UNITED STATES ENVIRONMENTAL PROTECTION AGENCY
WASHINGTON, D.C. 20460

OFFICE OF
AIR AND RADIATION

This letter revises the letter dated February 26, 1999, in which EPA issued its official determination of applicability under 40 CFR 72.6 of the Acid Rain Program for Mead Coated Board, Inc.'s ("Mead") generator #3 and its boilers and furnaces serving steam turbines #1 and #2. The facilities are owned and operated by Mead at the Mahrt pulp and paper mill ("the mill") near Cottonton, Alabama. In the February 26, 1999 letter, EPA determined that generator #3 and the boilers and furnaces serving steam turbines #1 and #2 are unaffected units under 40 CFR 72.6(b)(3) and (4)(ii), provided that they are operated in a manner consistent with the requirements of those regulations and the requirements and conditions noted in the letter. On March 17, 1999, Mead informed EPA that some of the information on which the determination in the February 26, 1999 letter was based was erroneous. In particular, the diagram (referred to as Figure 3) of Mead's facilities was inaccurate because the actual interconnections among steam turbines #1 and #2, generator #3, and the grid are more complicated than shown

Figure A

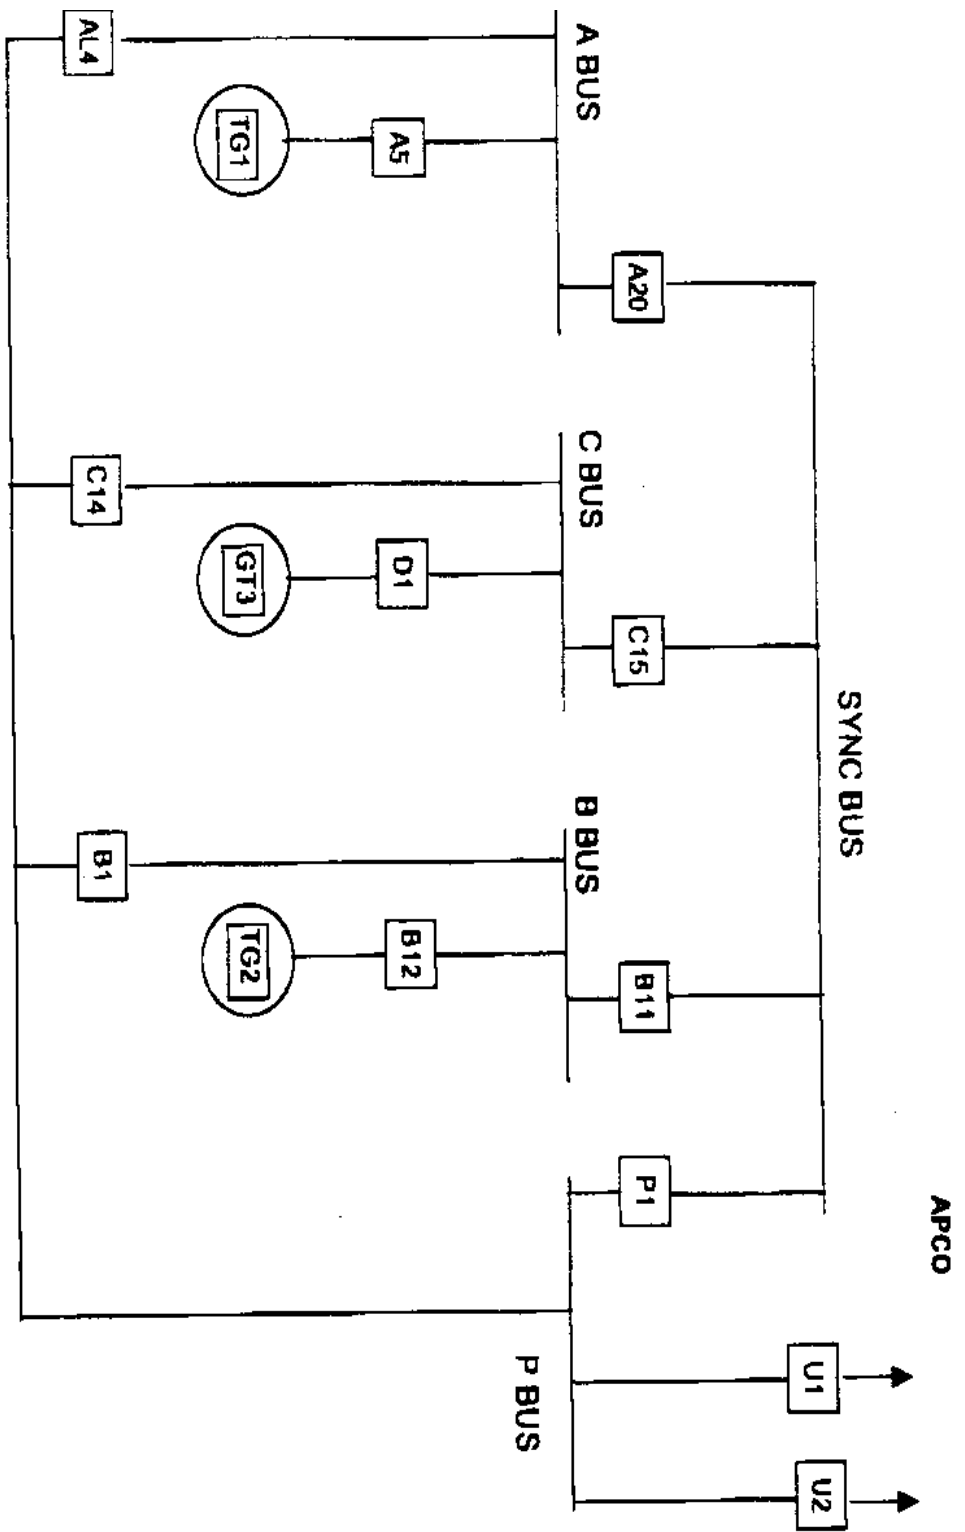
- a. Each reference in the February 26, 1999 letter to "Figure 3" is removed and replaced by a reference to "Figure A".

(a) Mead will sell only electricity produced by generator #3 (GT3 on Figure A) and will not sell any electricity when generator #3 is not operating.

(b) All electricity sold by Mead will be transferred through bus P and metered at breaker U-1 or breaker U-2. At any time, the sum of the amount of electricity metered, as flowing to the grid, at breaker U-1 and sold by Mead plus the amount of electricity metered, as flowing to the grid at breaker U-2 and sold by Mead must not exceed the amount in paragraph (b)(i) or the amount in paragraph (b)(ii). In metering the amounts at breakers U-1 and U-2 and calculating the sum of the amounts, Mead must subtract any amount of electricity metered, as flowing from the grid to bus P, at breaker U-1 or U-2.

(i) The amount of electricity metered at breaker D-1 (through which flows only power produced by generator #3).

(ii) The amount of electricity metered, as flowing to the synchronizing bus, at breaker C-15 (through which flows to the synchronizing bus all power that is produced by generator #3 and directed to the synchronizing bus). In metering this amount of electricity at breaker C-15, Mead must subtract any amount of electricity metered, as flowing to bus C, at breaker C-15.

2. As conditions for EPA’s determination, Mead must arrange and maintain the steam turbines #1 and #2 (TG1 and TG2 on Figure A), generator #3, lines, buses, and breakers as described in this letter and reflected in the attached Figure A and must meet the following data and recordkeeping requirements. Mead must meter continuously the electricity flows at breakers C-15, D-1, U-1, and U-2. Mead must keep records of such metered data for a period of at least three years from the creation of the data and must ensure that such data is accessible for audit by EPA upon request.”

c. Figure 3, attached to the February 26, 1999 letter, is removed and replaced by Figure A, which is attached to the instant letter.
